Certificate of Appropriateness

Property	1677 N. Farwell	Brady Street HD
Description of work	Repair fire escape primarily by welding, but with additional work specified in attached drawing. Repair one window on second floor. The window's method of operation shall not be changed. All materials shall be replaced in kind or restored to original condition. No metal wrap is permitted. Installation of weather stripping is encouraged. <u>The window shall not be replaced.</u>	
Date issued	12/12/2022	PTS ID N/A

RELEASE	3/2/22	
No.	Revision/Issue	Date
Drawn By: MJS		
Checked By:		
Project Name and Location REPAIR TO FIRE ESCAPE MILWAUKEE, WI		
Drawing No.	542028-1	
Date	2/4/22	Sheet
Scale	1/1

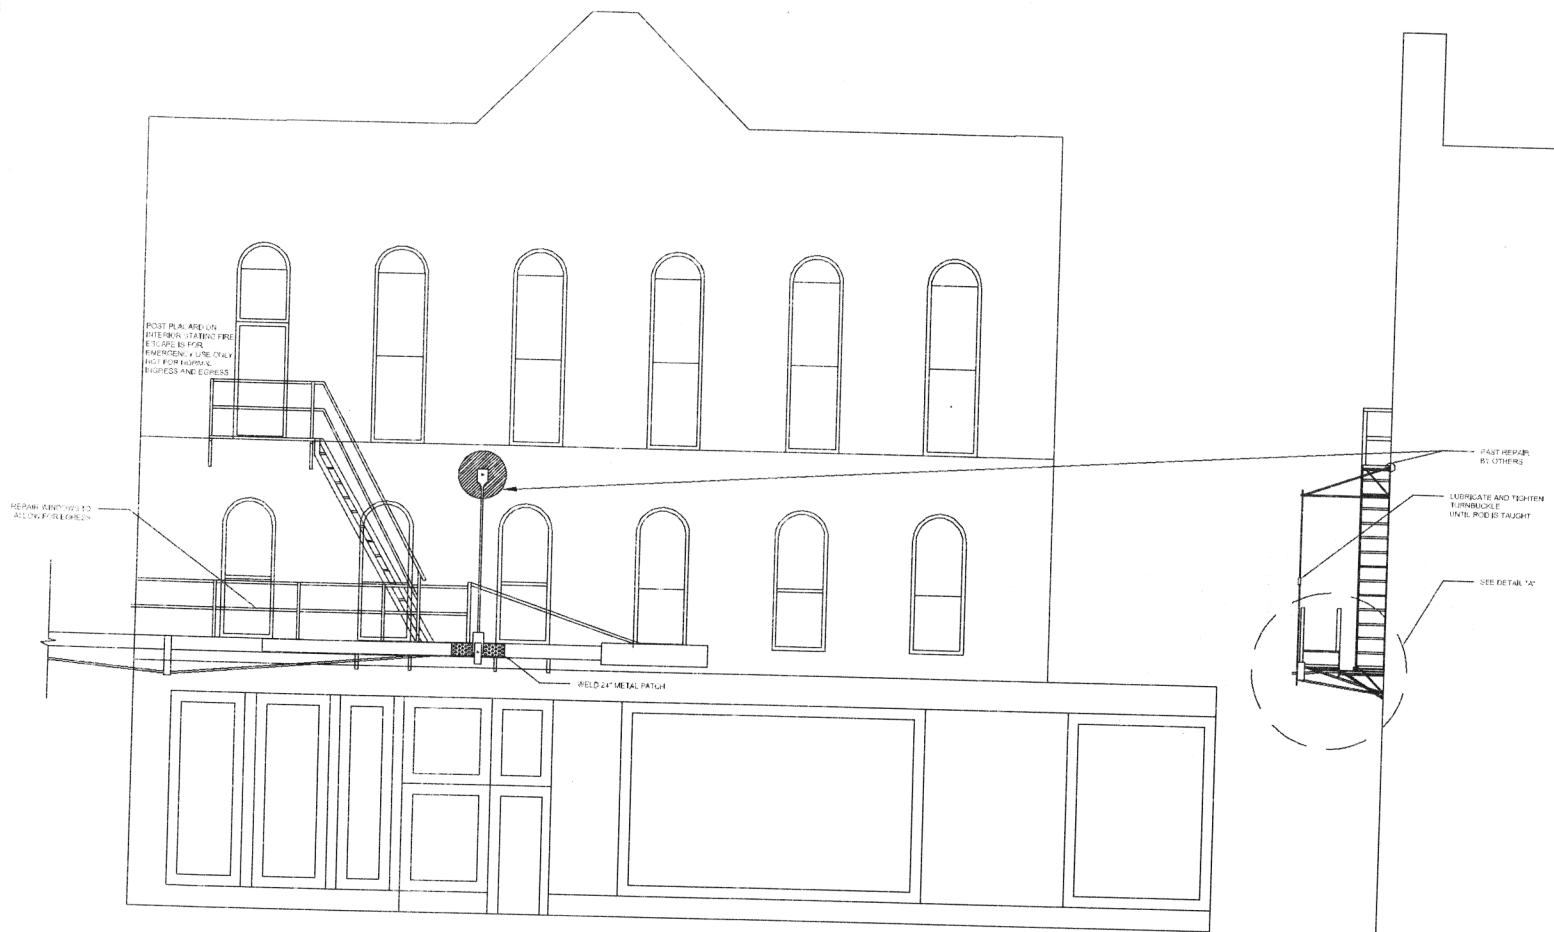
All work is on the Farwell façade and the subject window is the second floor south window
